PLANNING NOTES AMENDMENT

Project:	Lower Town House Barn Townhouse Road, Littleborough OL15 9JX		
Title:	Proposed Section B - B		
Client:	Vernon Wharmby		
Drawn By:	WRS	on	12/08/2024
Original Size:	A2	Project Number:	1017 / 13
Drawing Number:	13 A

Section B - B (through H1 & H2)
scale 1:25

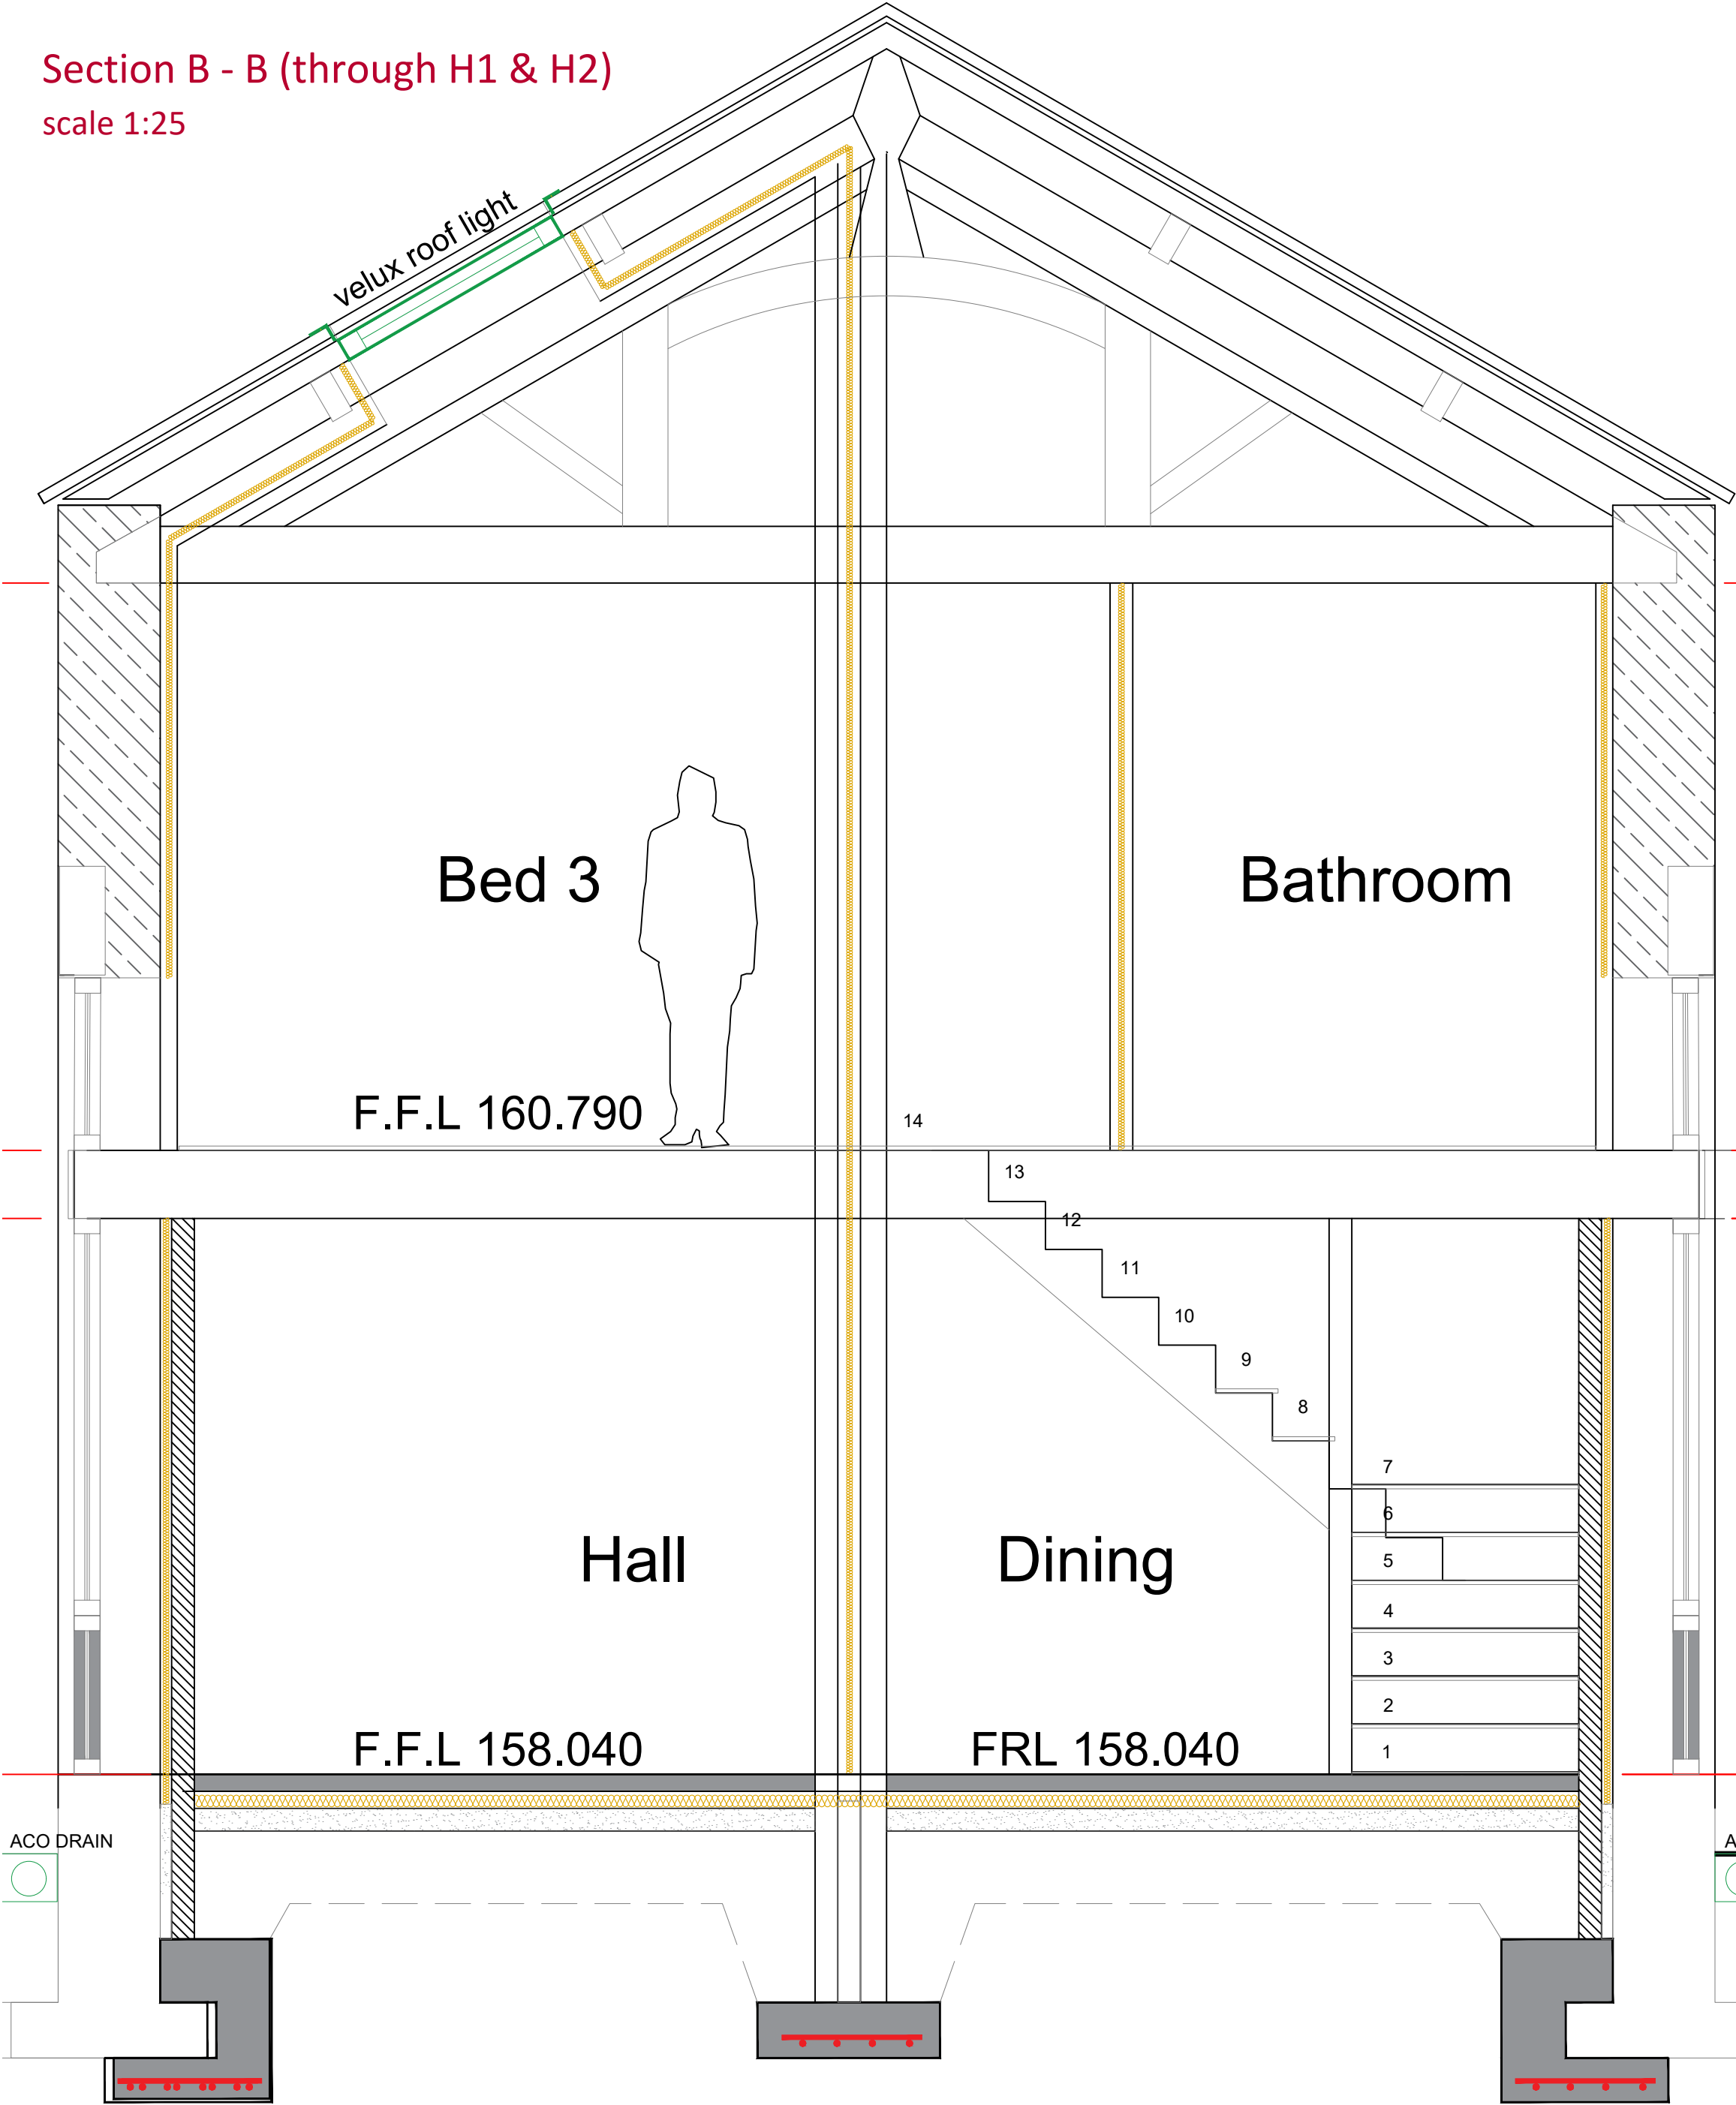
A - 02/11/25 - FFL level raised by 200mm to suit FRA / FFL level = 158.040 and EA requirements
ACO Drainage system incorporated to front & rear building lines - connected into surface water drainage system
